Remediation Mitigation Report – Cootes Paradise and Western Harbour – FINAL (Version 3)

Cootes Paradise Report
City of Hamilton
Project #WW20101062

Version	Document Date	Submitted	Description of Revisions
1.0	March 26, 2021	March 26, 2021	None – Original Document
2.0	April 23, 2021	April 23, 2021	Updated report in response to MECP comments issued April 9, 2021. The responses to the comments were addressed in a response matrix dated April 23, 2021.
3.0	May 21, 2021	May 21, 2021	Updated report in response to MECP comments issued May 7, 2021. The responses to the comments were addressed in a response matrix dated May 21, 2021.

Figure 1. Cootes Paradise Average Year Total Phosphorus Loading

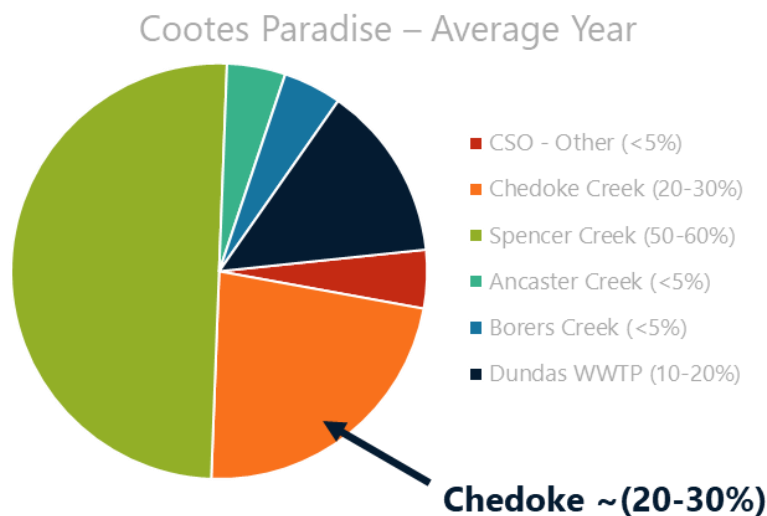
Date Received	From	Section	Page	Comments	GMBP Response
23-Feb	Conservation Hamilton	1.2	3	Figure 1 and 2 seem to be reversed. The text refers to Figure 1 as the overall watershed yet the Figure 1 shows the lower urbanized area of the watershed. I think that Figure 1 should be Figure 2 and Figure 2 should be Figure 1.	
23-Feb	Conservation Hamilton	General	N/A	The report does acknowledge that the high-level estimations of loadings need further assessment to more accurately define them. These assessments would dovetail with HCA flow monitoring efforts in Chedoke Creek and Lower Spencer Creek to better determine loadings.	
23-Feb	Conservation Hamilton	General	N/A	The report seems to focus on enhancement options to aspects that have quite small contributions to an average year nutrient loading (CSO, landfill, Highway 403), while the biggest contributor (Stormwater) is typically a lower priority.
